April 4, 2022

Site Plan Review and Special Land Use

Site: 18411 W. 14 Mile Road
Applicant: Engineering Services, Inc.
Plan Date: March 15, 2022
Zoning: O Office District
Parcel ID: 24-14-226-048
Proposal: Special Land Use

Image of existing buffer fence along south property line. -Source: Google Street View

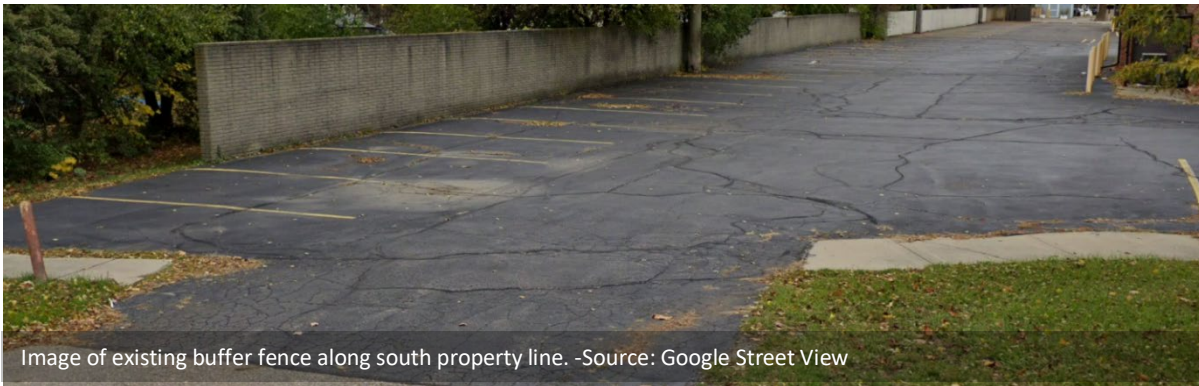
- a. It shall be a continuous and solid face brick, masonry, or stone wall at least five feet high (but not more than six feet high) as measured from the side of the wall farthest from the R1 district as finally and properly graded. ***The site plan identifies an existing, 8'-0" wall along the south property line separating the subject site from the adjacent R-1 Single-Family Residential District. The wall may be an existing, non-complying structure, but the plans should address the following, in item 'b' below:***

- b. It shall be at least eight inches thick and reinforced with steel, pilasters, or the equivalent and shall provide for proper drainage to flow through or around the wall in accordance with sound engineering practice. ***The applicant should provide additional information pertaining to the existing barrier wall.***
